City of
Richmond

Report to Development Permit Panel

File: DP 13-643519

Re: **Application by Christopher Bozyk Architects for a General Compliance Ruling at
11100 Cambie Road**

PLAN #3
 DP 13-643519

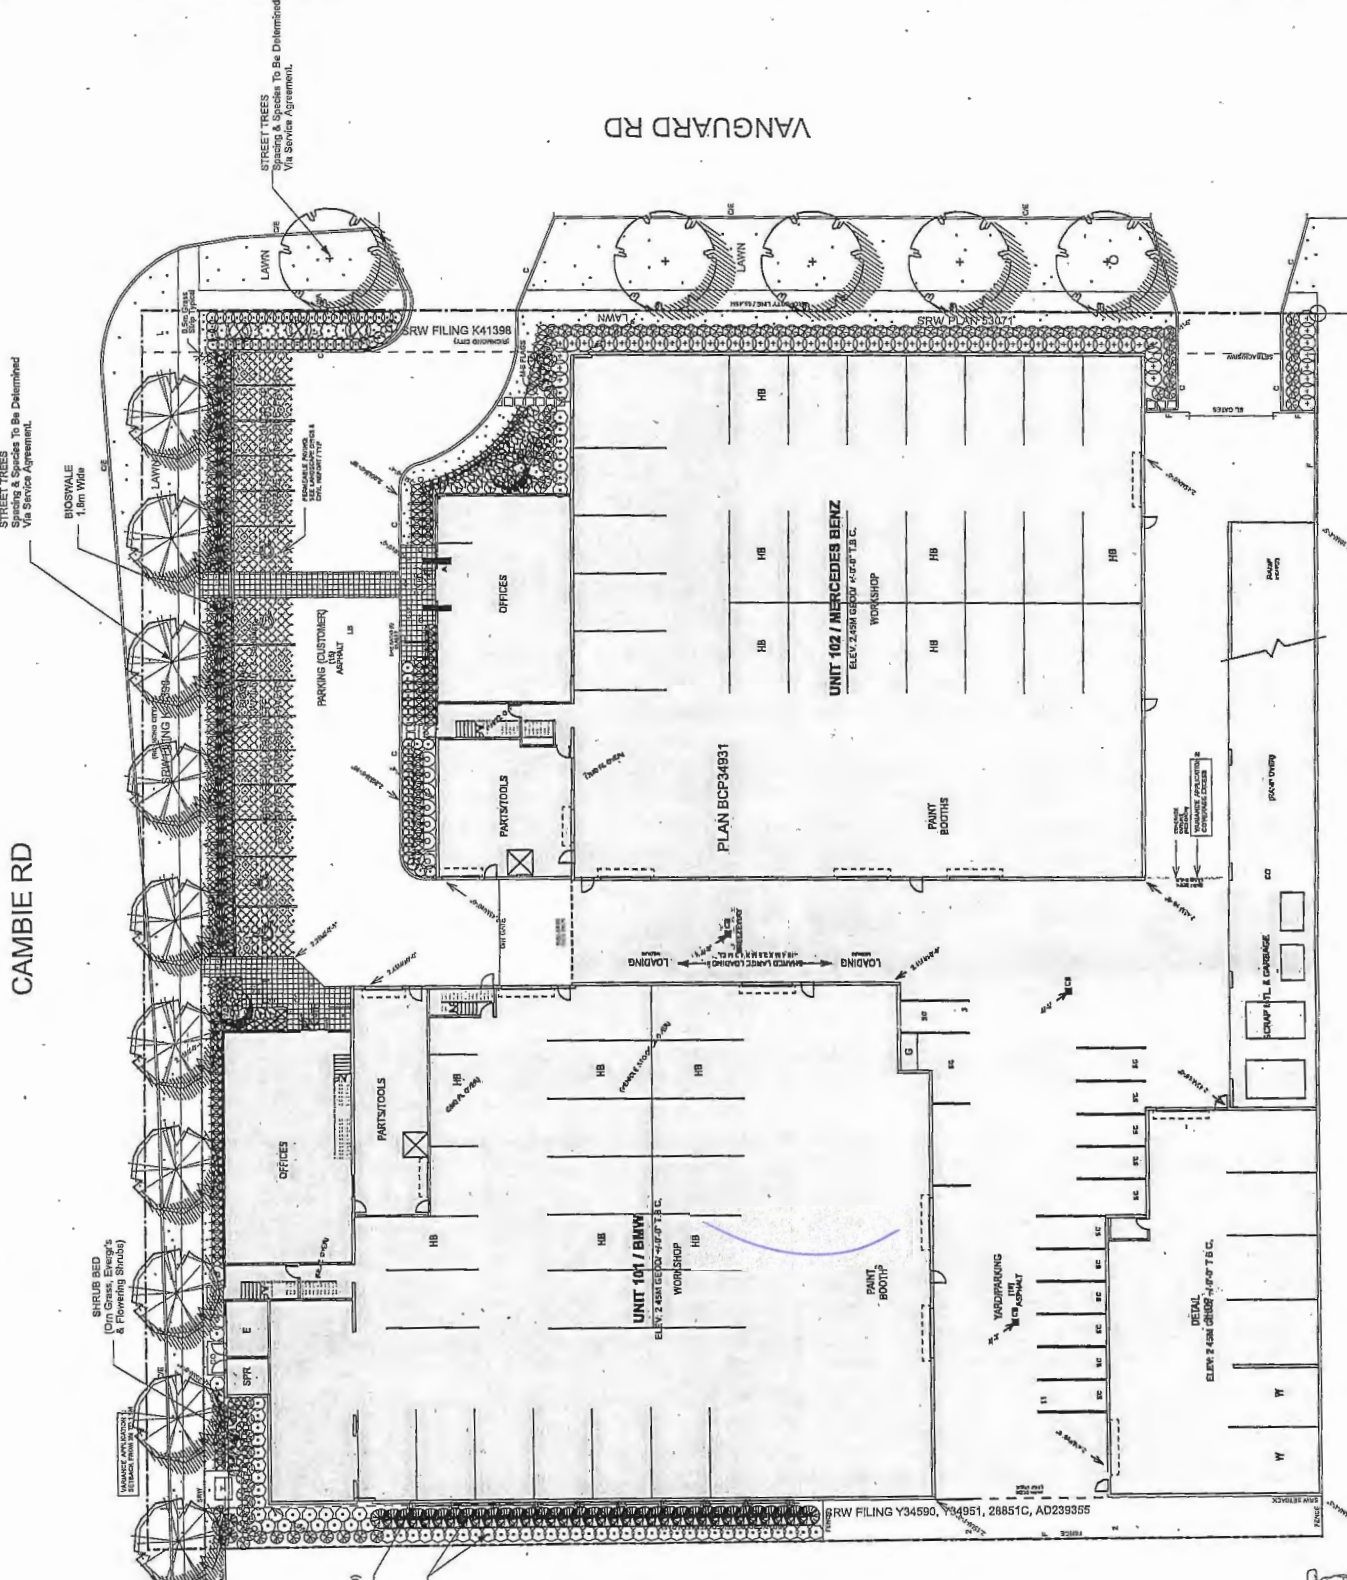
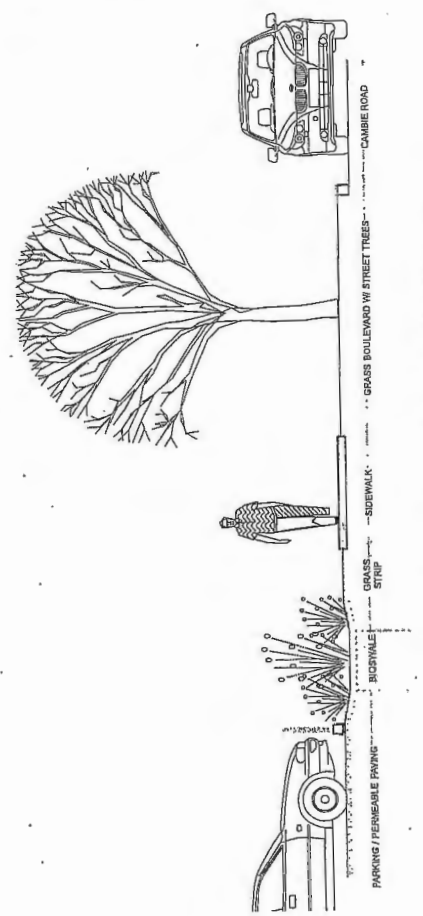
The combination of proposed plant reductions in front of the Mercedes Benz building and increased plantings along the front of the BMW building will result in both plant selection and quantity changes to the approved landscape planting list. The approved and proposed landscape plans are provided in Attachments 2 and 3 respectively. The changes will result in a net loss of 63 shrubs from the approved planting list. Given the limited space on site and the changes imposed by the undergrounding of the hydro lines there does not appear to be an opportunity to compensate for this loss within the property. The proposed landscaping will still meet the minimum requirements for landscaping under Richmond Zoning Bylaw No. 8500, and while one proposed row of evergreen hedge will not be provided on the west property line – in order to meet BC Hydro requirements – the green wall feature using boston ivy will be retained on the west wall, and one row of Otto Luyken laurel will be retained adjacent to the building.

PROPOSED LANDSCAPE CHANGES

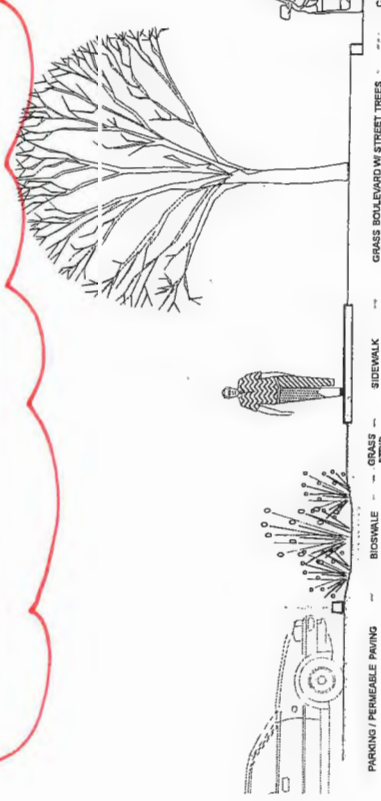
During construction of the eastern building on the site – the Mercedes Benz building - building and column footings along the front (north) resulted in concrete being higher than anticipated. This reduced the space available to install sufficient growing medium and drainage to support the planting originally anticipated along the front of the building. The Architect has advised that the problem did not become apparent and problematic until the site work stage. This is the area where the river rock garden is shown in revised drawing L.1 Proposed Landscape Changes (attached).

In partial response to the proposed reduction of the planting along the front of the Mercedes Benz building and to address the potential for soil in the remaining planting areas migrating from the landscaping area onto the City sidewalk as a result of a slight grade difference between the landscape bed and the sidewalk (at a lower elevation), the owner installed a low retaining wall and will create a raised planting bed adjacent to the sidewalk. Planting in this area is proposed to be increased over the original landscape plan submission.

The proposed changes to the planting scheme along the fronts of the two (2) buildings address problems with the approved landscaping design given the adjacent building construction. Resetting foundation footings for the Mercedes Benz building would entail significant cost and, given the advanced state of construction, would likely not be feasible. The substitution of the decorative river rock will create an attractive, low maintenance frontage for the building.

The raised planting bed allows additional planting in partial compensation for the loss of vegetation in front of the Mercedes Benz building and also alleviates a future concern of bedding soil finding its way over the adjacent public sidewalk.

11100 CAMBIE RD
 NEW COLLISION DAMAGE REPAIR FACILITY
 DEVELOPMENT PERMIT APPLICATION
 # DP 13-643519
ELEVATIONS

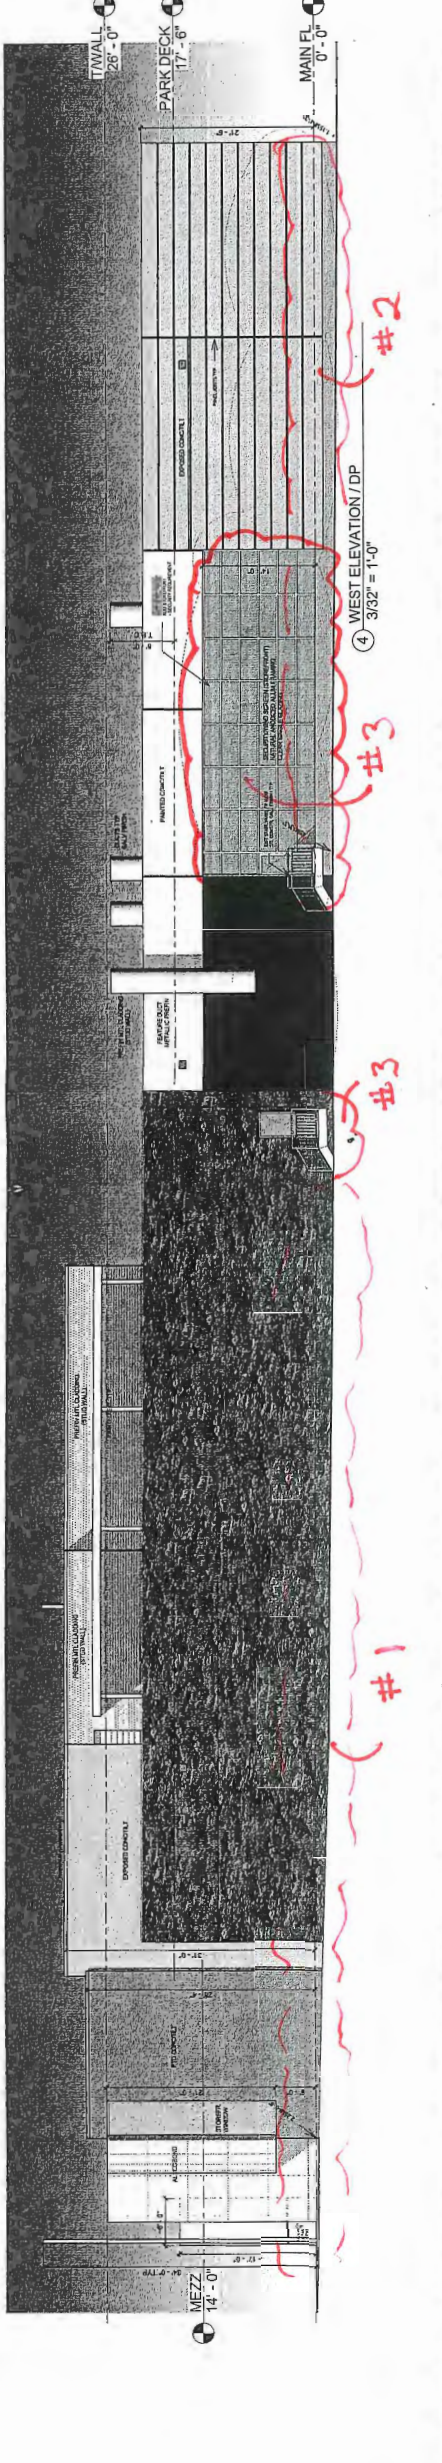
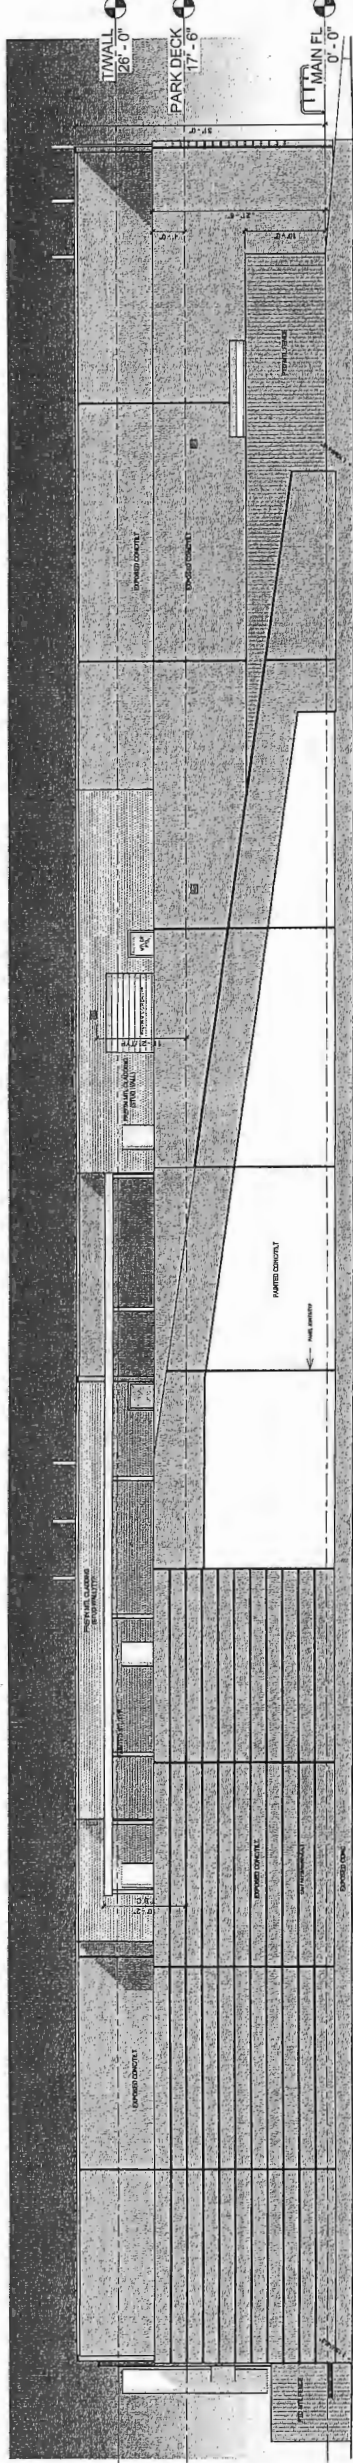
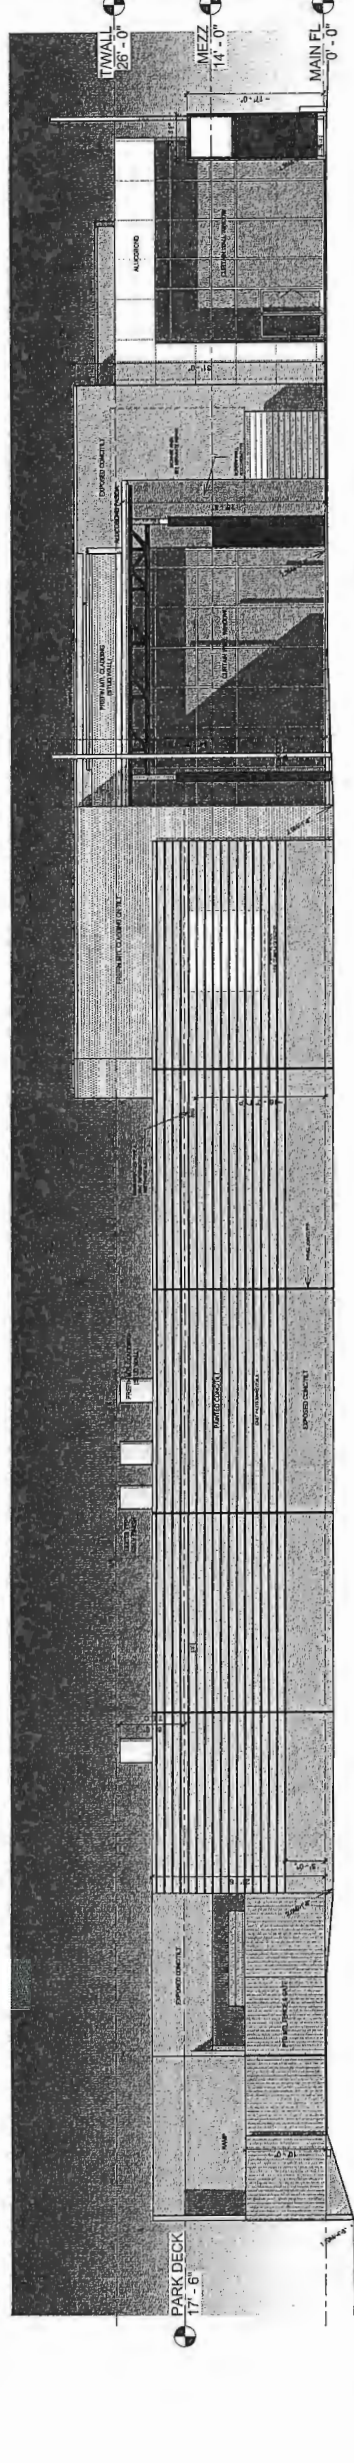
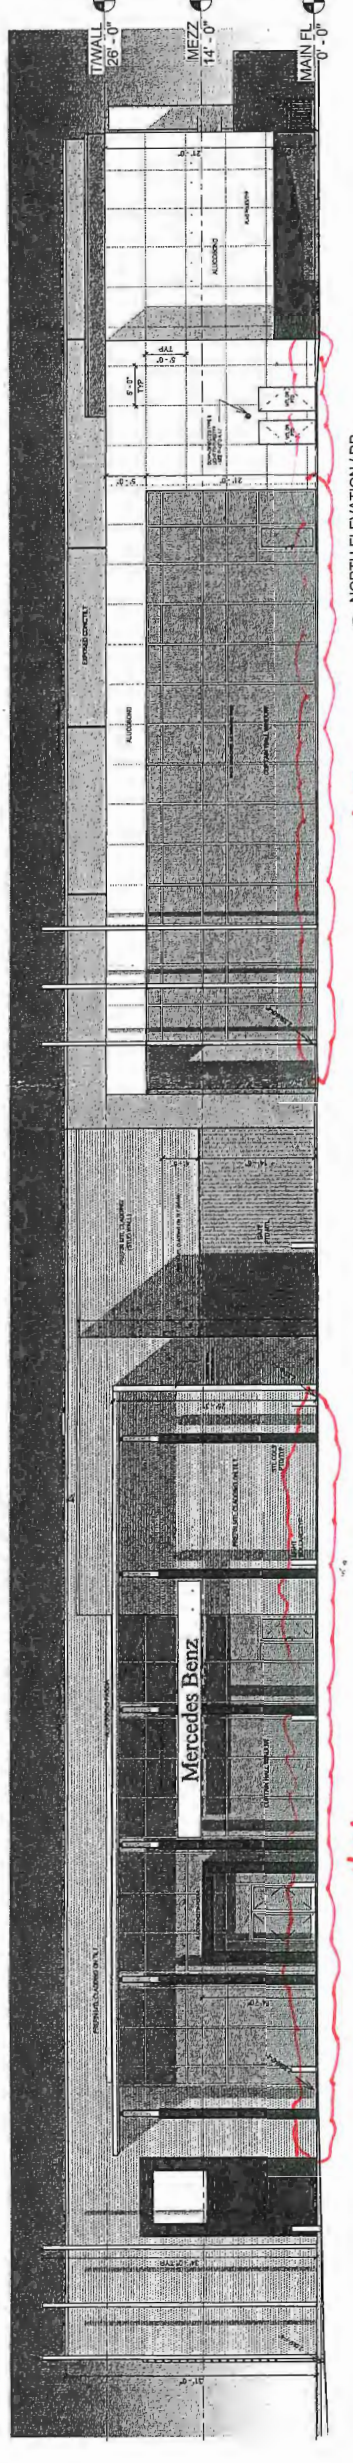
1. Enclosure of an open space between the BMW building and the Detail Shop with a glazed curtain wall between the two (2) buildings. Two emergency access doors and removable stairs have also been added in the vicinity of the window screen area;
2. Landscaping and fencing changes along the northern half of the western property line within the BC Hydro right of way, as required by BC Hydro as a result of the decision to underground power lines along the west property line; and
3. Other landscape changes.

With the removal of the security fencing along the west property line, the owner was concerned that the open access along the western side of the building as approved in the Development Permit, would create security concerns. In response, the owner closed in the open space between the BMW building and the Detail Shop with a glazed curtain wall. Emergency access doors and removable steps have also been added along the west side of the building. The addition of the glazed curtain wall does not increase the floor area of the building, as the open space was roofed above, and space remains open at both ends.

All of the changes along the western side of the building (items 1 through 3) have been in response to decisions made by BC Hydro to underground Hydro power lines that was not foreseen by the applicant or by BC Hydro in their initial project review. The loss of the security fence is a significant concern to the owner/operator of the facility which will house expensive tools and equipment as well as client vehicles. The addition of the window curtain wall improves their situation by reducing this security concern. The closure of the open space between the two (2) buildings does not create additional interior area since the drive aisle remains open from two (2) other directions. Building Approvals have been alerted to the addition of the curtain wall and have reviewed any implications in terms of adequate ventilation in the drive aisle space.
